**MEASURE DD IMPLEMENTATION PROJECT  
NOTICE OF AVAILABILITY OF FINAL ENVIRONMENTAL IMPACT REPORT (FINAL EIR)  
AND NOTICE OF A PLANNING COMMISSION MEETING TO CERTIFY THE FINAL EIR**

**CASE NO.:** ER 06-0017 (State Clearinghouse Number 2006122048)

**PROJECT SPONSOR:** City of Oakland

**CITY OF OAKLAND MEASURE DD  
IMPLEMENTATION PROJECT  
ENVIRONMENTAL IMPACT REPORT  
RESPONSE TO COMMENTS**

Answer to boat

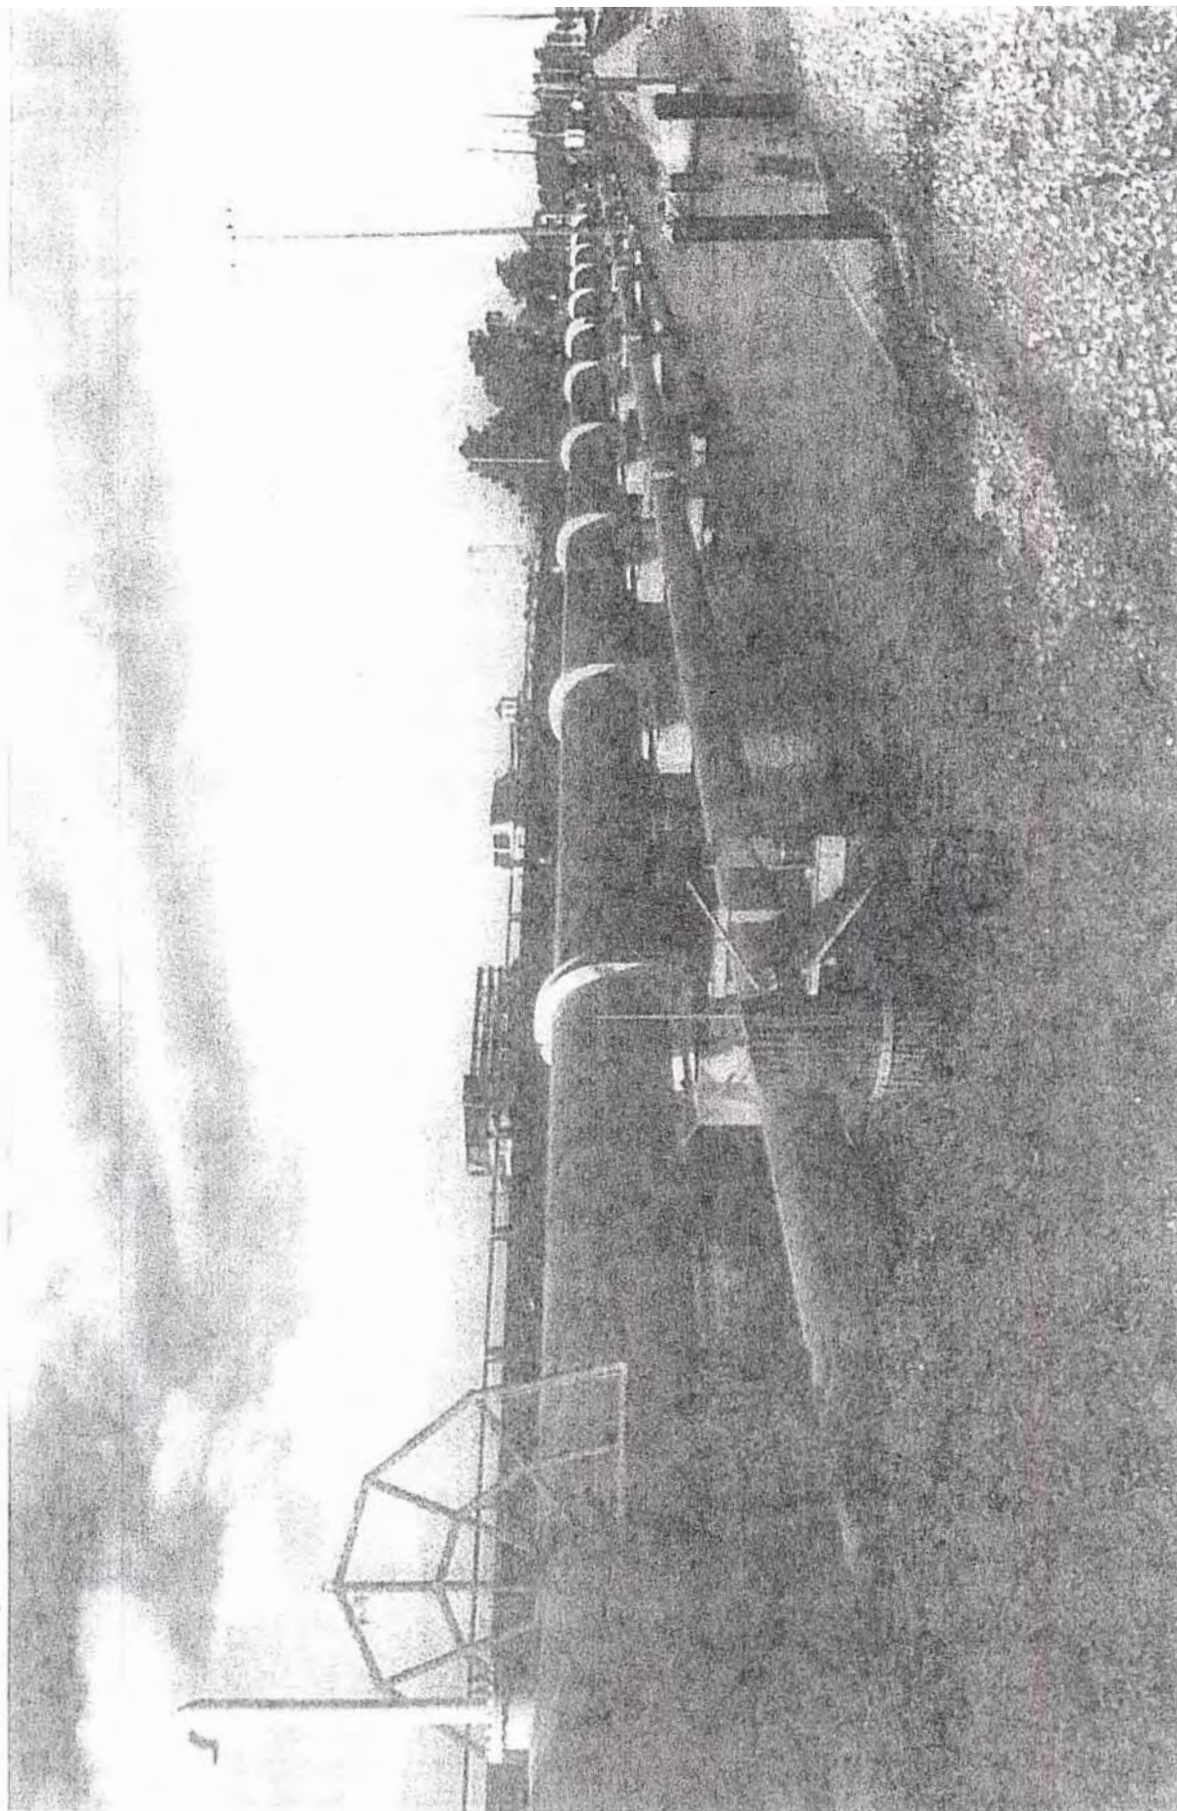
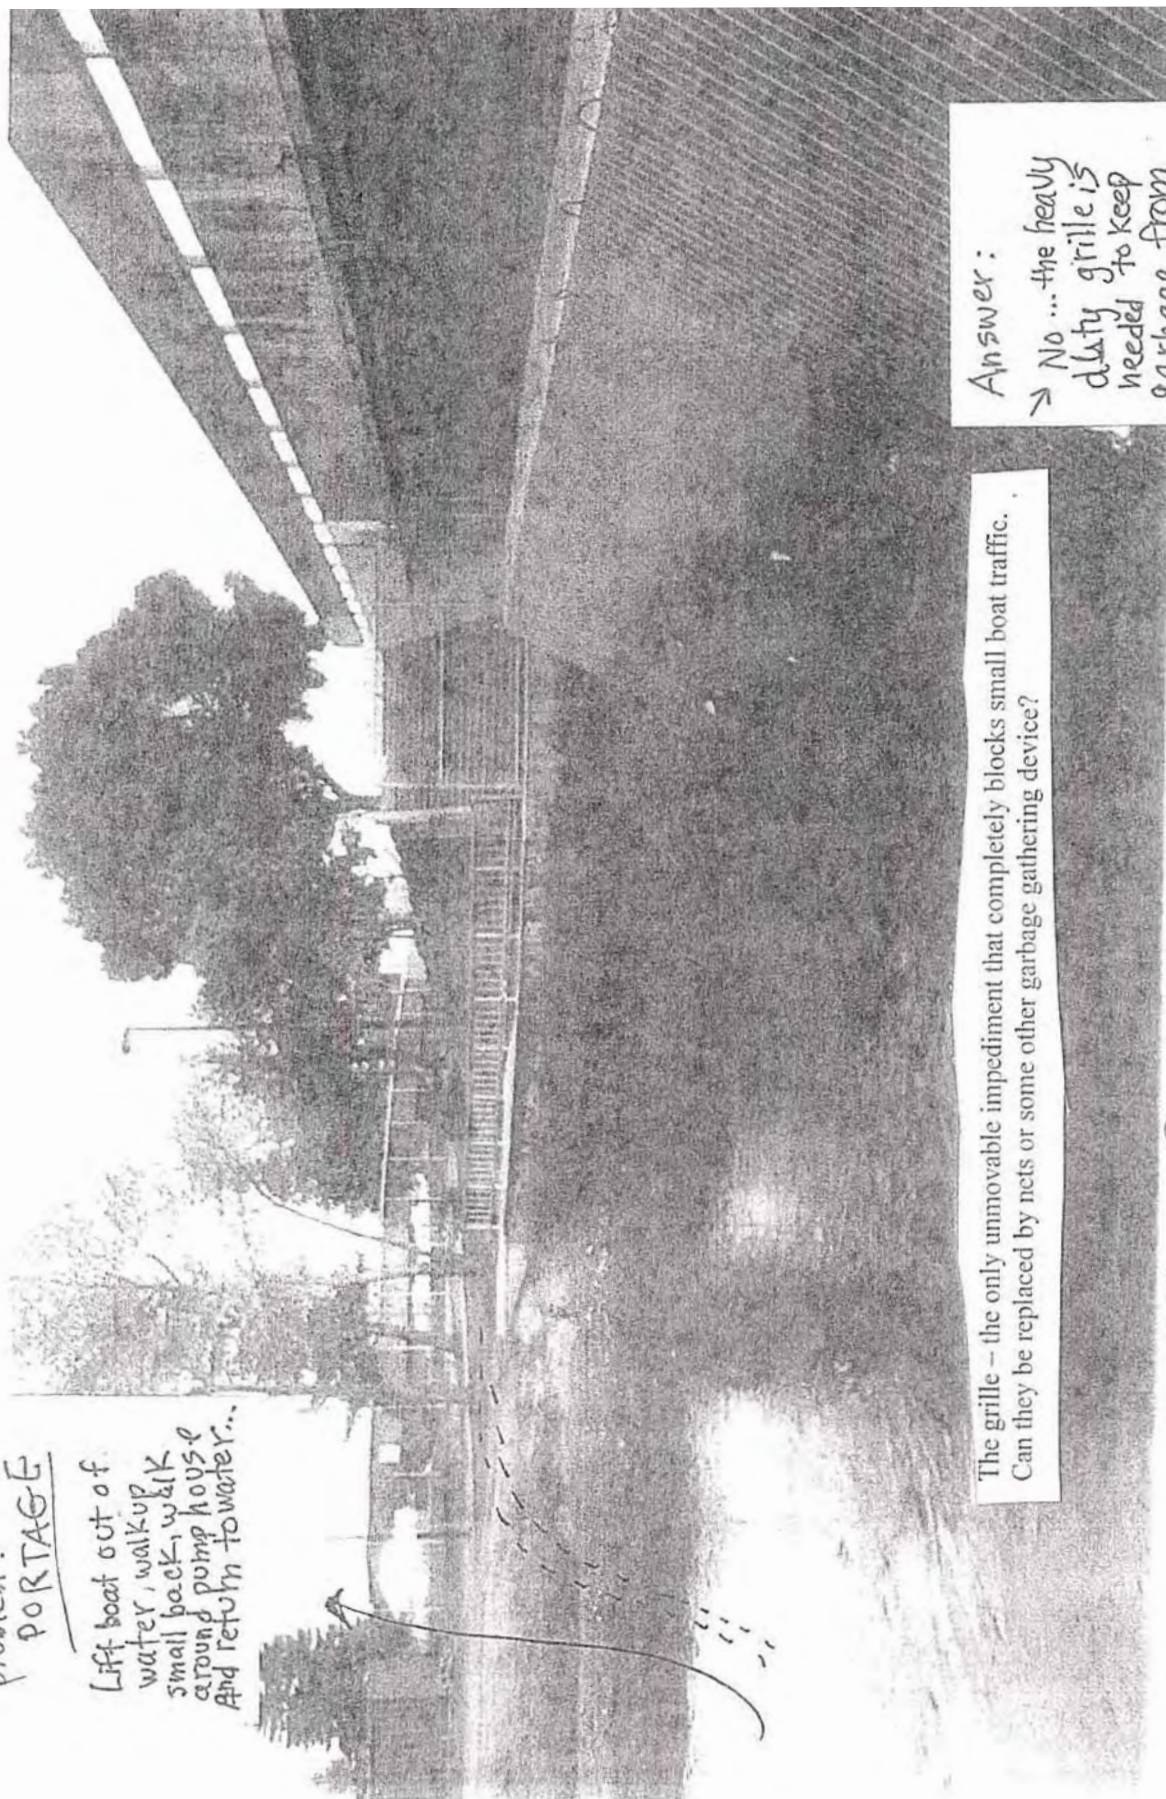
Lift boat out of  
water, walk up  
small back, walk  
around pump house  
And return to water...

The grille – the only unmovable impediment that completely blocks small boat traffic.  
Can they be replaced by nets or some other garbage gathering device?

→ No ... the heavily  
dirty grille is  
needed to keep  
garbage from  
wrecking the  
pumps.
